LINCOLN PARK PLANNING COMMISSION

970 Fort Street – Auto Sales and Services

Site Plan Review

Applicant	Mohammed Aoude
Project	Auto Sales and Service
Address	970 Fort Street, Lincoln Park, MI 48146
Date	September 9 2020
Request	Final Review – Special Land Use
Recommendation	Approve with Conditions

SHEET #: SP-4

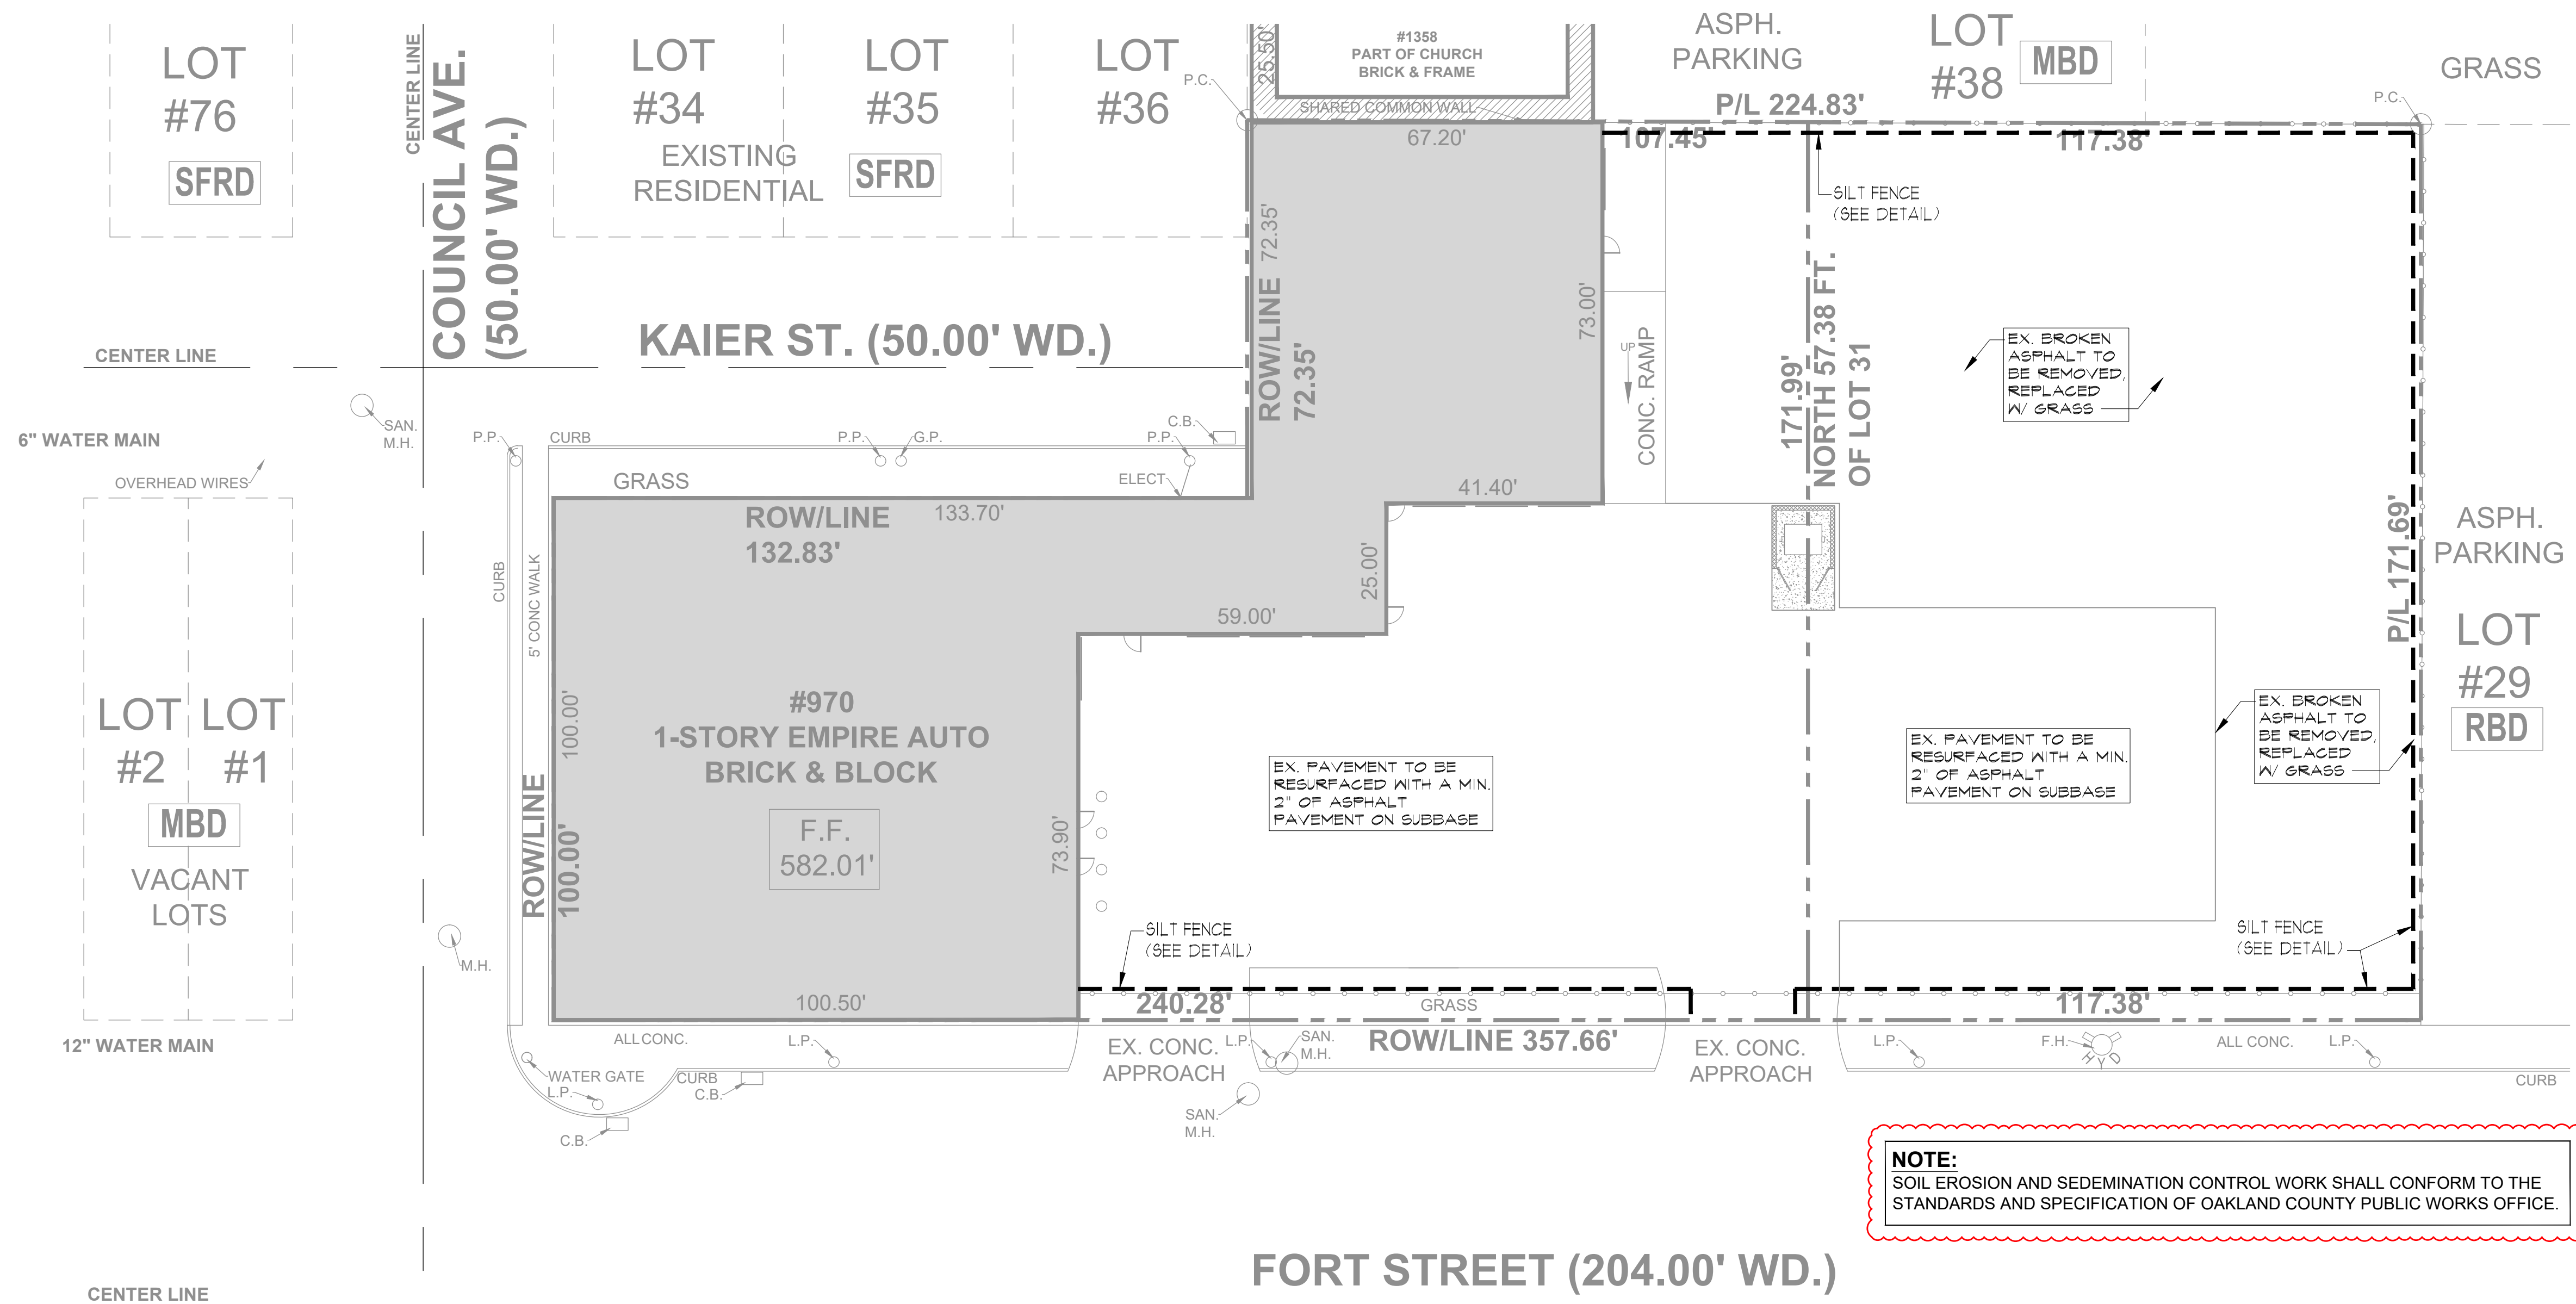
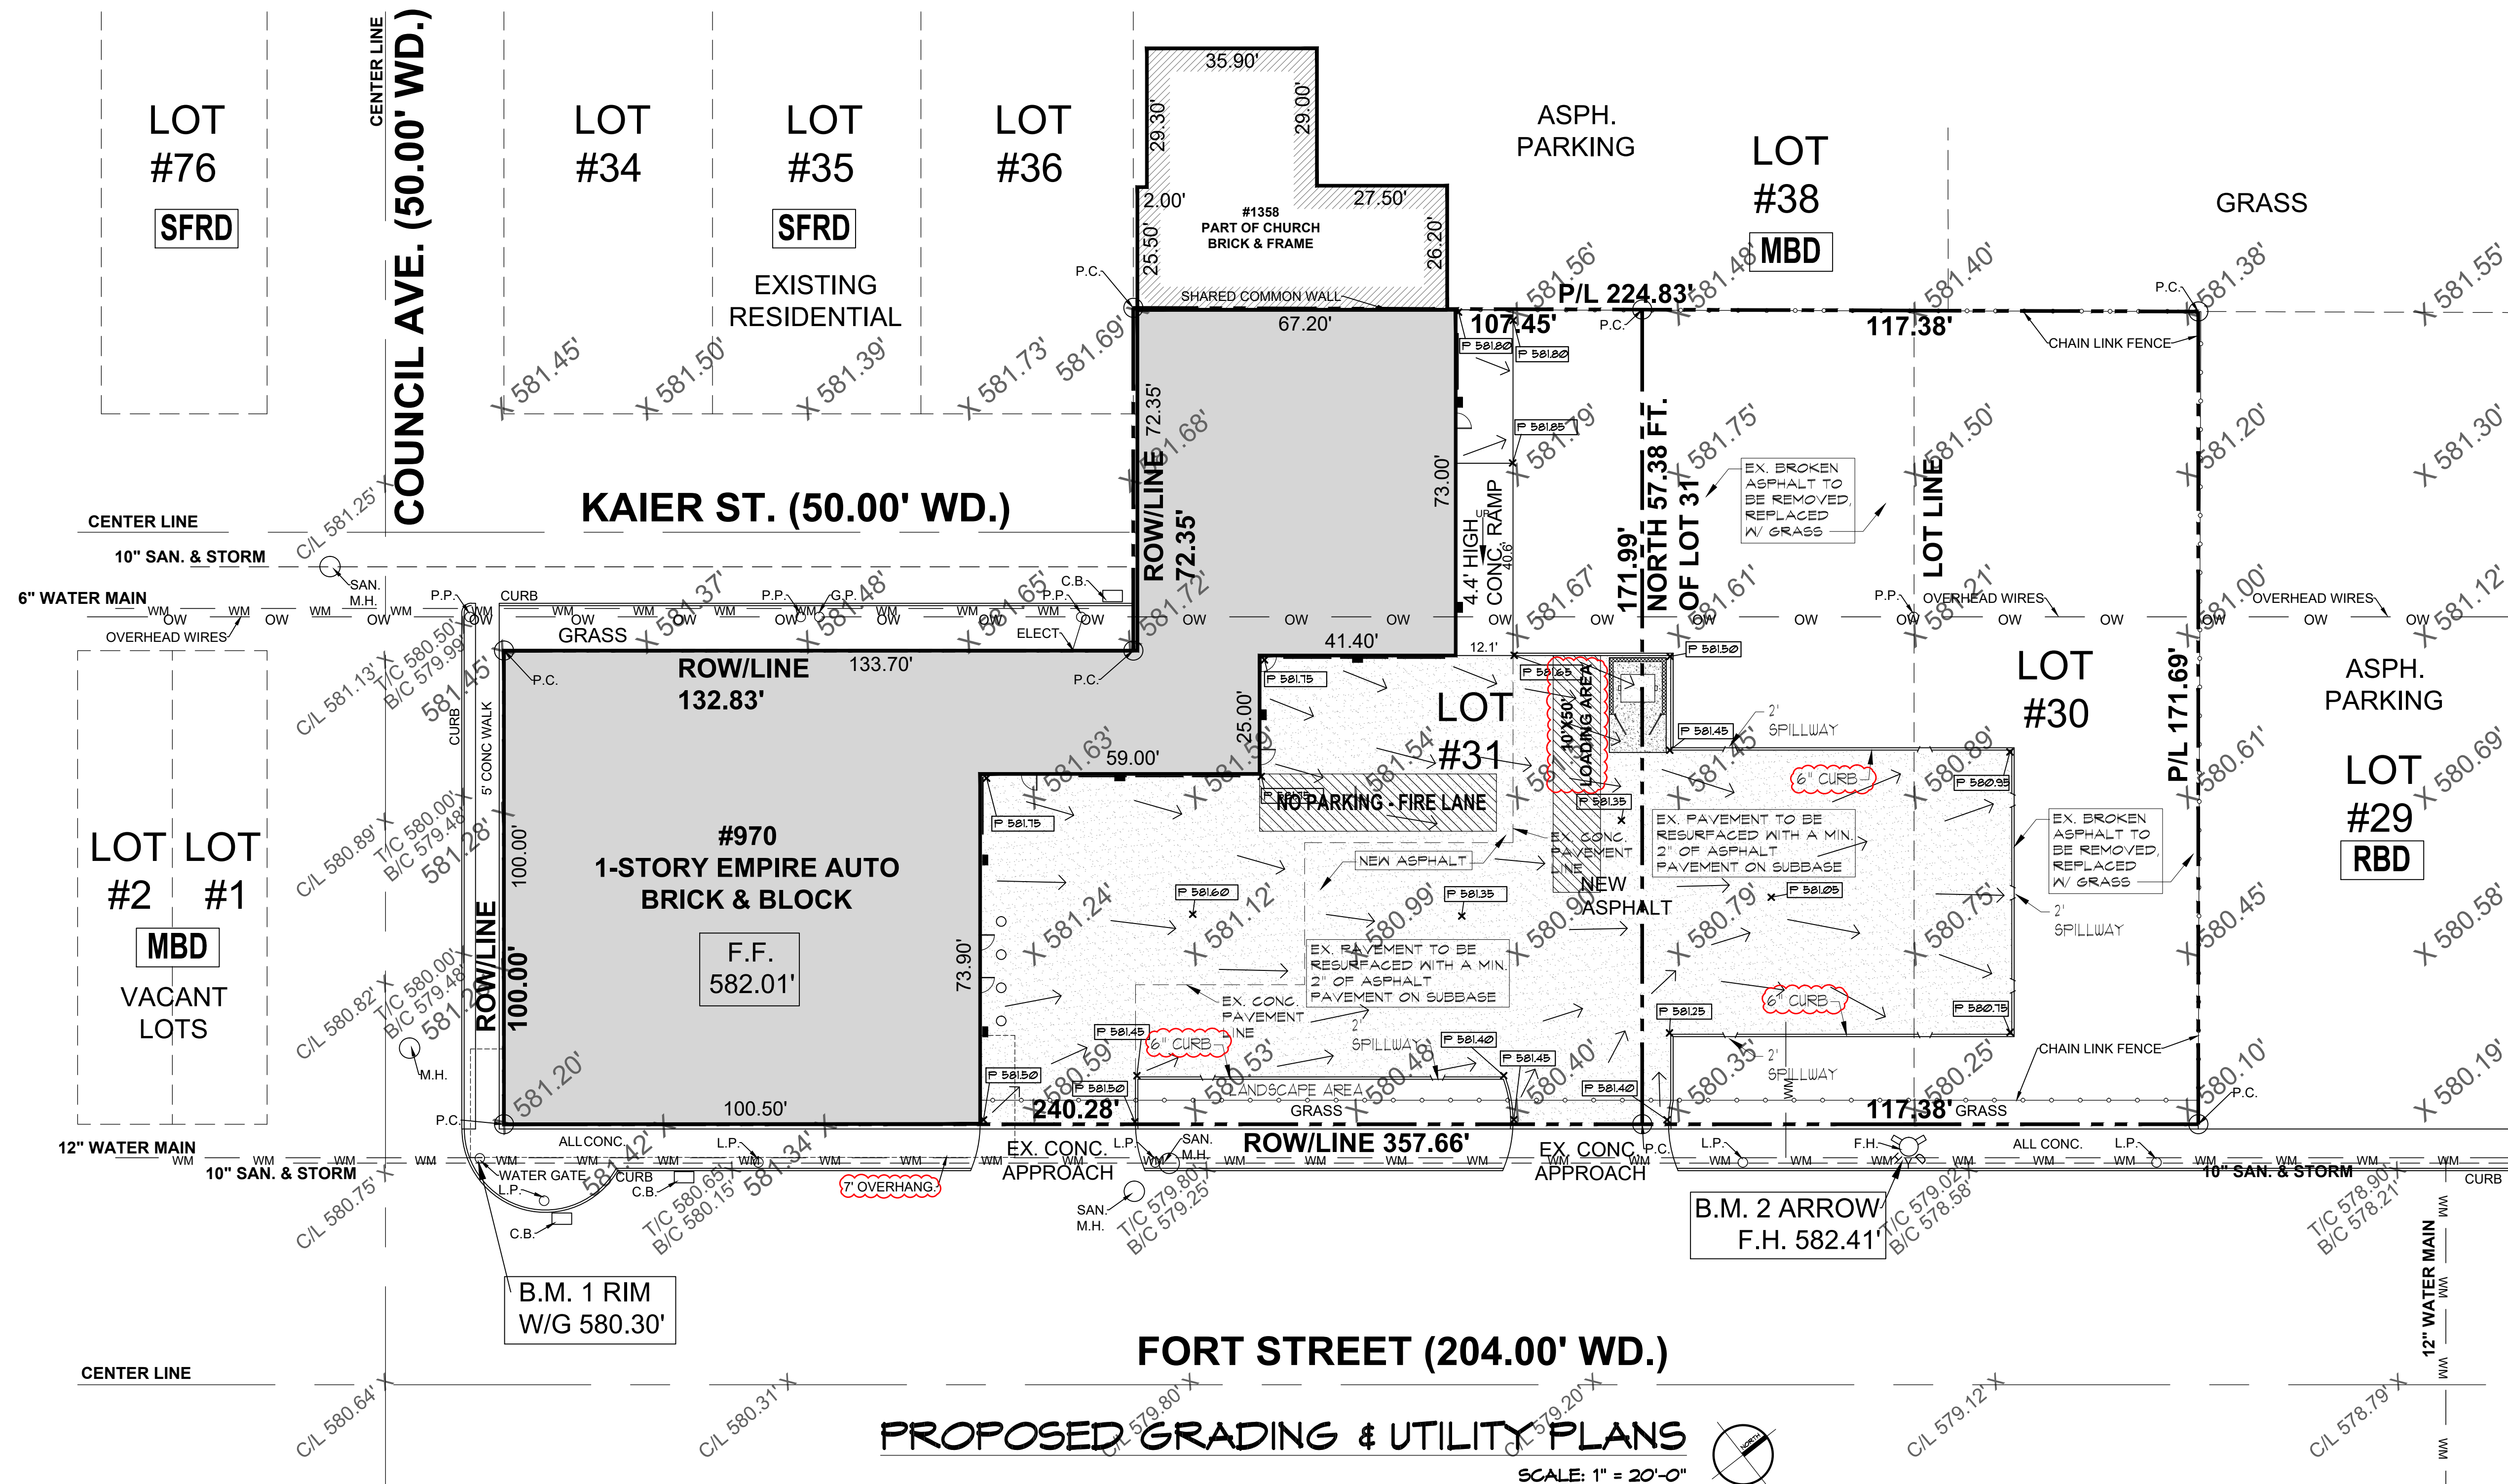
1. Based on the site plan submitted, all existing utilities and leads are being reused. It is our recommendation that the new addition should be serviced by new water and sanitary sewer services. If the existing services are approved for tie-in by the Plumbing Inspector it is important that the developer realize these existing utilities are very old and may have reached their life expectancy. It is our strong recommendation for the developer to at least videotape the existing sewer lead to determine its condition prior to doing any renovations on the existing building. If the service lead needs to be replaced the installation of the new service will need to be inspected by our office. The developer should verify with the City the existing sanitary service type and size. If it is undersized for the proposed building use it must be replaced. The developer's engineer or architect shall determine the sanitary service lead capacity.

2. The developer should verify with the City the existing water service type and size. If it is a lead service or if the service is undersized for the proposed building use, it should be replaced. The developer's engineer or architect shall determine the water service lead capacity.

- *Applicant shall verify with the City the existing sanitary service type and size. If It Is undersized for the proposed building use It must be replaced. The applicant's engineer or architect shall determine the sanitary service lead capacity.*

- *Applicant shall verify with the City the existing water service and size. If It Is lead service or If Is undersized for the proposed building use, it shall be replaced. the applicant's engineer or architect shall determine the water service lead capacity.*
